- 5. Patson Properties Cude Addition No. 2; KPB File 2026-059
McLane Consulting Group / SBC 2012 Family Trust
Location: Patson Road**

**ITEM #5 - PRELIMINARY PLAT
PATSON PROPERTIES CUDE ADDITION NO 2**

KPB File No.	2026-059
Plat Committee Meeting:	June 22, 2026
Applicant / Owner:	The SBS 2012 Family Trust
Surveyor:	Andrew Hamilton/ McLane Consulting Inc
General Location:	Patson Dr off Funny River Rd /

STAFF REPORT

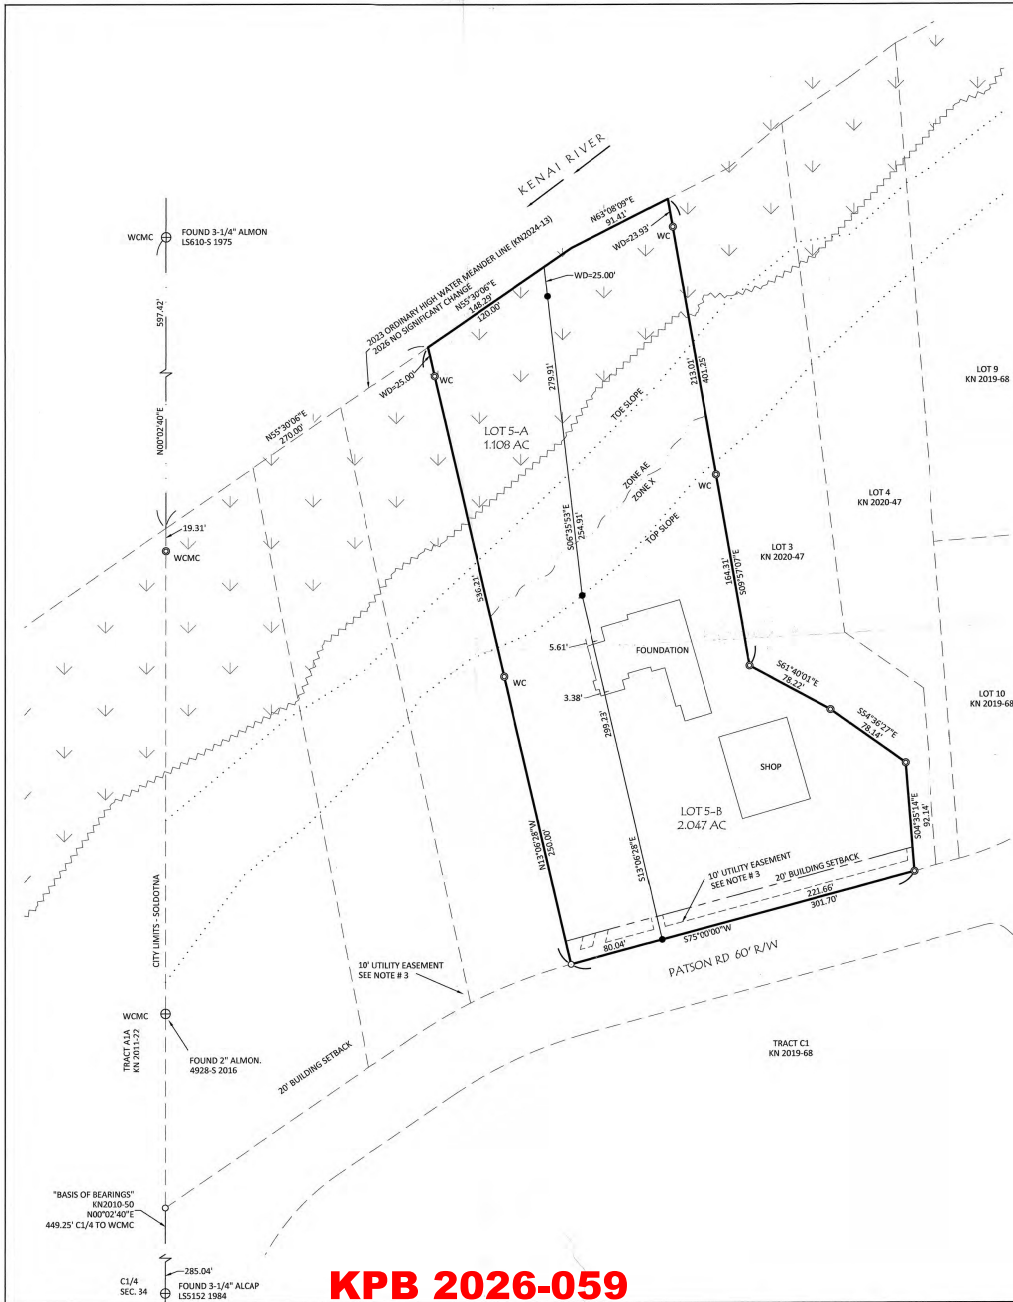
KPB Roads Dept. comments	Out of Jurisdiction: No Roads Director: Uhlin, Dil Comments: The foundation encroaches the new property line.
SOA DOT comments	No comment

The subdivision is located along the Kenai River and has steep slopes over 20 percent as indicated with the top of slope and toe of slope. **Staff recommends** the top and toe of slopes remain on the final plat.

There are improvements shown on the drawing of a shop and the start of a foundation for a house. The owner stopped work on the foundation when it was found that the new division crossed through the edge of the foundation. The owner has stated they plan to cut the foundation back from the new property line. **Staff recommends** prior to final approval of the plat that an as-built survey of the foundation be submitted to staff verifying the location of the foundation and clearance from the new property line.

Per the River Center review the plat is located in both a FEMA designated Flood Hazard Area and Flood Zone. Notes from KPB 20.30.280 (D) and (E) should be included on the drawing. They should include the FEMA FIRM Panel and the Flood Zones should be included in 20.30.280(D). **Staff recommends** the FRIM Panels be corrected to the current as listed by the River Center Administrator as noted below.

The plat is also in a Habitat Protection District and the drawing should include the plat note from KPB 20.30.290.

A soils report will not be needed as the report for Patson Properties Cude Addition KN 2024-13 covered this same area. The engineer who completed the soils report for the parent plat was consulted on the report and he noted that they had done the adjacent testing for plats that overlapped into this one also. The same results were achieved for a conventional onsite wastewater treatment system. Staff recommends the Wastewater Disposal note be revised to match the note in KPB 20.40.020(B)(1)

10' Utility Easement and Boulding Setback notes hanging to the west for no reason, please remove
Add dimensions to the section line to the west to complete line and connect front and back corners of Lot 8.
Change the date in plat note 11 to June 22, 2026
In the Plat Approval, change the date to June 22, 2026

- Staff recommendation:**
Modify the KPB File no to 2026-059
In the name, move 'owner' to the first line as the Title.
Verify the mailing address, Suite B is not given on the mailing of the Assessors page.

- C. The location, width, and name of existing or platted streets and public ways, railroad rights-of-way, and other important features such as section lines or political subdivisions or municipal corporation boundaries abutting the subdivision;
Staff recommendation:
Label Lost Smoke Ave & ROW width to the southeast

- D. A vicinity map, drawn to scale showing location of proposed subdivision, north arrow if different from plat orientation, township and range, section lines, roads, political boundaries, and prominent natural and manmade features, such as shorelines or streams;
Staff recommendation:
Vicinity map is showing larger area than being platted, please refine area.
Label Patson Rd

- G. The status of adjacent lands within 100 feet of the proposed subdivision boundary or the land status across from any dedicated rights-of-way that adjoin the propose subdivision boundary, including names of subdivisions, lot lines, block numbers, lot numbers, rights-of-way; or an indication that the adjacent land is not subdivided;
Staff recommendation:
Lots to the west need labeling

- N. Apparent encroachments, with a statement indicating how the encroachments will be resolved prior to final plat approval;
Staff recommendation:
Encroachment shown. Owner plans to cut foundation back. Will need asbuilt prior to final approval.
